Access Compliance Report

Public Rights-of-Way

Intersection ID: 17792	Main Street: COLWICK_RD	Cross Street: CHISWICK_RD	Location: NE
ADA ID: B5F55F5CE1C8	Ramp Type: Perp	Initial Pass/Fail: Pass	Overall Compliance: No
		Severity Score: 0

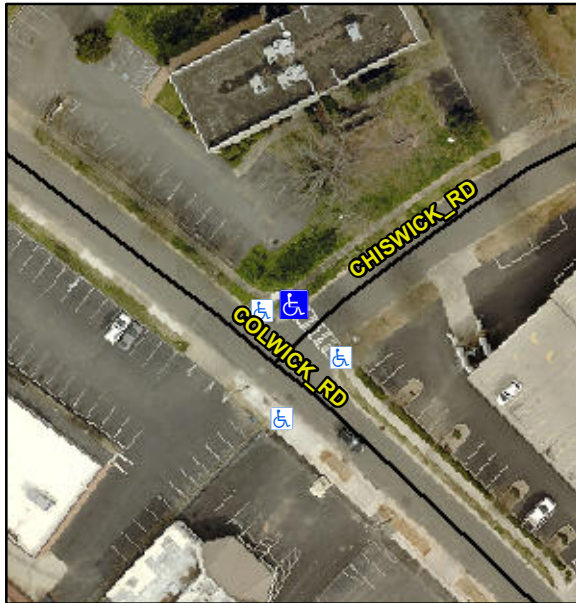
Remove & Replace Landing.

R304.2.2-Perp, R304.3.2-Para
